HOSHIZAKI AMERICA, INC.

SERVICE BULLETIN

SB04-0011

Subject: **BROKEN BIN CONTROL BULB COUNTERMEASURE**

Note: Generic picture of bulb holder, capillary and silicone tube. The respective deflector or thermostat extension bracket not shown.

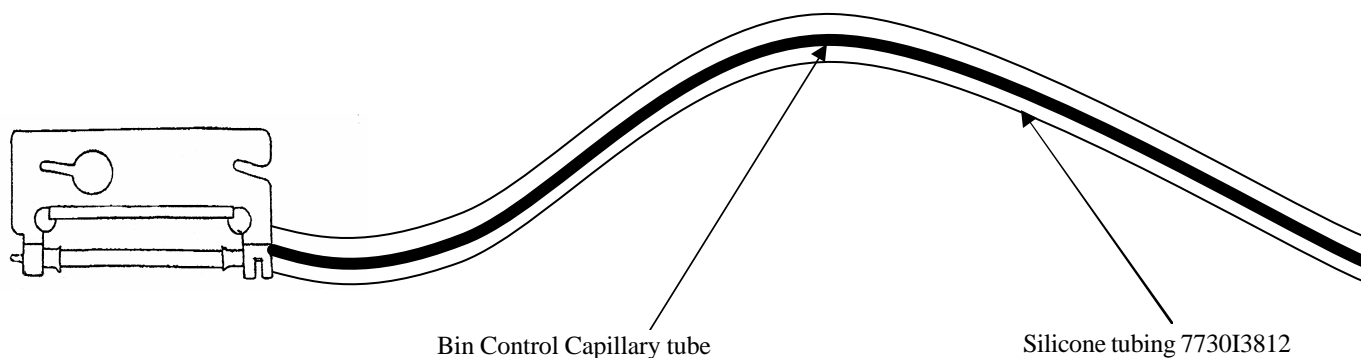
Beginning in March 2004 the KM-280M_H, KM-500M_H, KM-630M_H as well as the KML series will include silicone tubing along the portion of the bin control capillary located in the ice drop zone. **There were also changes made to the mounting bracket and capillary routing on the KML series and the KM-900.** This will help protect the bin control capillary from ice impact “pinging” during the harvest cycle.

This tubing **will also be added** to all TB0030 and TB0040 bin controls. **When replacing the bin control this tubing should be installed..** One length of tubing will be sent with these kits. **The tubing must be cut to** fit flush against the front cover it will not pass through the front cover, also route the tubing and **capillary** in a matter as to get the least amount of ice “pinging” as well as not to catch water inside tubing.
